FRONT FENDER MOUNTING / 1975 TO EARLY 1980 FL MODELS

As noted in Service Letter No. ML-136, we have decided to declare this a safety defect and we are recalling all potentially affected vehicles in compliance with the National Traffic and Motor Vehicle Safety Act. All following potentially affected 1975 to Early 1980 vehicles within VIN range 10000-H5 to 31341-J0 must be remedied as soon as possible by installing the special Code 045 Service Kit, Part No. 93316.

FIGURE 1. OLD STYLE FRONT FENDER MOUNTING.

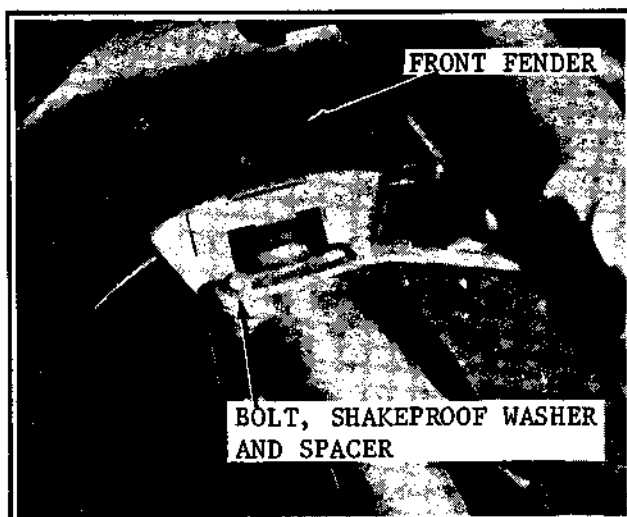
The front fender mounting bolts on 1975 to Early 1980 FL, FLH, FLHS models can loosen after extended vehicle use. (See Figure 1.) If undetected, the loosening could result in bolt loss or failure which could allow the fender to contact the tire. During operation, this could cause the tire to skid and the motorcycle operator to lose control.

FIGURE 2. PROPER TORQUE METHOD FOR BRACKET MOUNTING SCREWS.

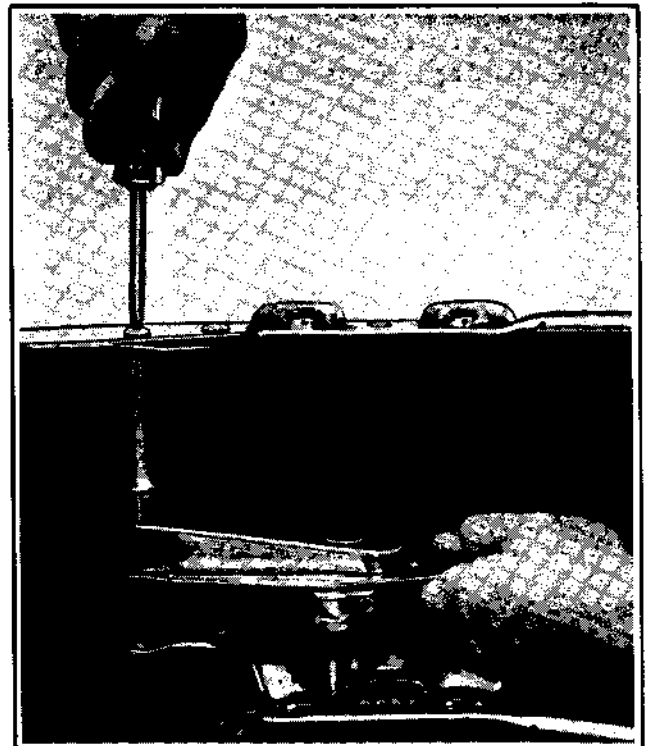
14. When installing new brackets from Kit on inside wall of fender, note that the left side bracket has a special tab for properly routing the brake line. Insert screw through fender and bracket from outside, apply Loctite (Red grade, Part No. 99626-77) to screw thread, attach nuts and torque each of the five nuts on each bracket to 60 in-lbs torque. (See Figure 2.) The use of a lower strength Loctite can result in loosening of the nuts.

Hold the screw head stationary while torquing the nut to prevent gouging of the fender paint under the screw head. (See Figure 2.)

FIGURE 3. FRONT BUMPER MOUNTING
1977 AND LATER MODELS.

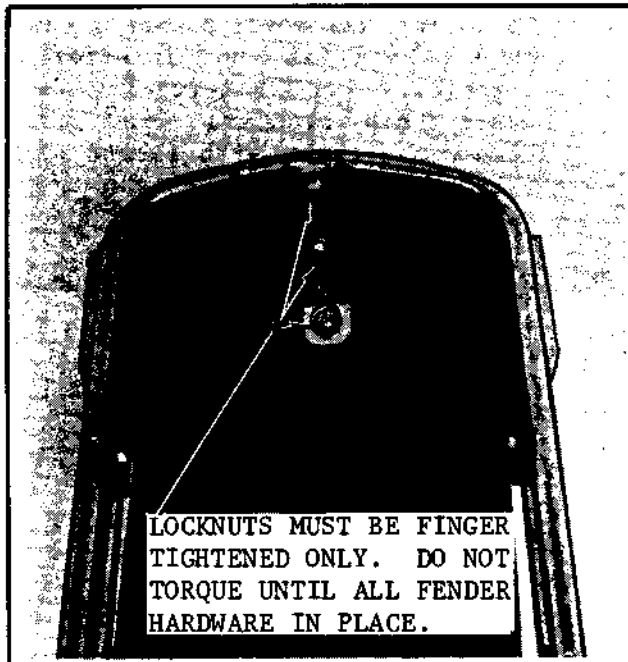
15. If bumper is used, reattach to the front fender and finger tighten nuts only. If 1977 & Later bumper, remember to use the new yellow front

bumper bracket and hardware from Kit. **DO NOT** tighten or torque until all other bumper attachments are in position to prevent preloading of the bumper assembly. (See Figure 3.)

FIGURE 5. FENDER BRACKET MOUNTING
LOCK PLATE.

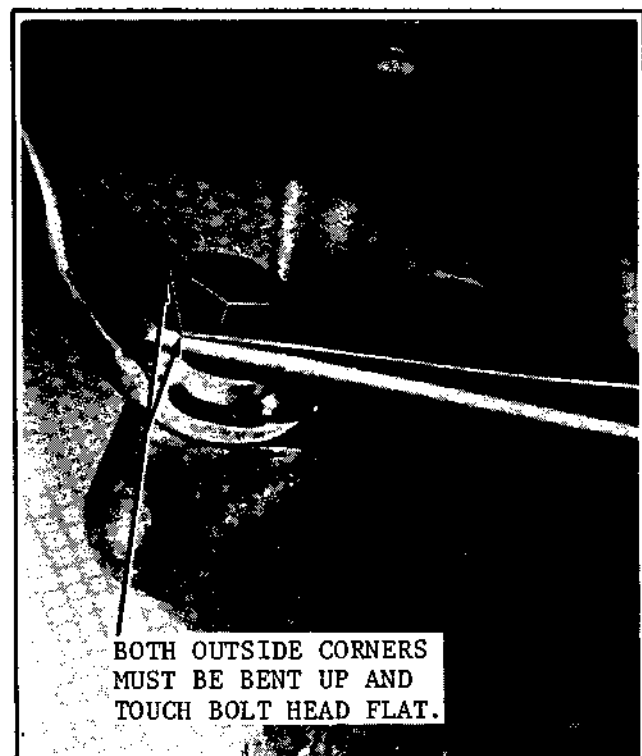
19. After the front bumper hardware is secure, then torque four yellow colored fender mounting bolts to 20 ft-lbs torque. After torquing, bend both outside end corners of lock plate in to touch the flat of each bolt head. (See Figure 5.)
20. Reinstall front wheel. Align the brake pads while installing so the brake disc goes between the pads. Tighten axle nut to 50 ft-lbs torque. Secure two slider cap nuts and torque to 11 ft-lbs torque. (See "Wheels" Section of 1978½ FL, FX Service Manual.)
